Access Compliance Report

Public Rights-of-Way

(Curb Ramps)

Intersection ID: 13443	Main Street: KEE_CT	Cross Street: W_SUMMIT_AV	Location: W
ADA ID: 01E98659F5E3	Ramp Type: BlendTrans1	Initial Pass/Fail: Pass	Overall Compliance: No
Severity Score: 0			
Codes/Mitigation Info/Possible Solution		Field Measurements/Component Compliance

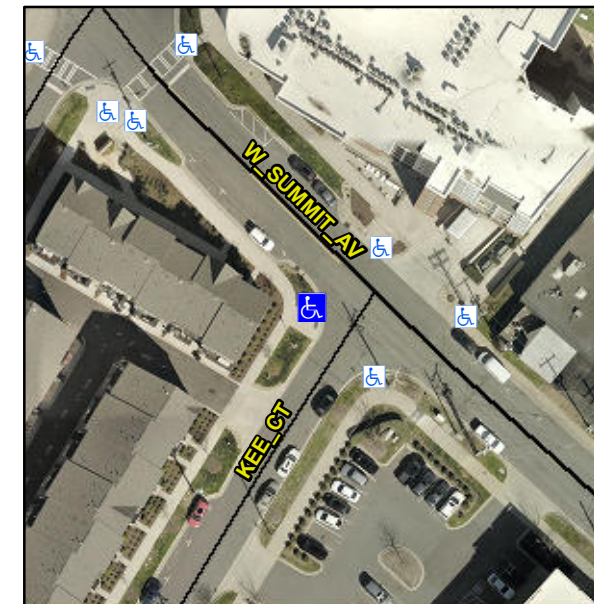
Not Found, R305.2

N/A	Ramp inside XWalk1?	N/A	N/A	Ramp inside XWalk2?	N/A
	Road Slope (%)	1.1		Clear Space?	Yes
	Road X Slope (%)	0.9	N/A	Clear Space to XWalk (in)	N/A
Yes	Any Obstructions?	No	Yes	Storm Grate/Utility Hazard?	No
	Obstruction Type			Storm Grate/Utility Type	
		N/A			N/A
			Yes	Surface Condition? (G/P)	Good
			No	Curb Slope (%)	6.8

Remove & Replace Curb Ramp With Two New Directional Ramps or Equivalent.
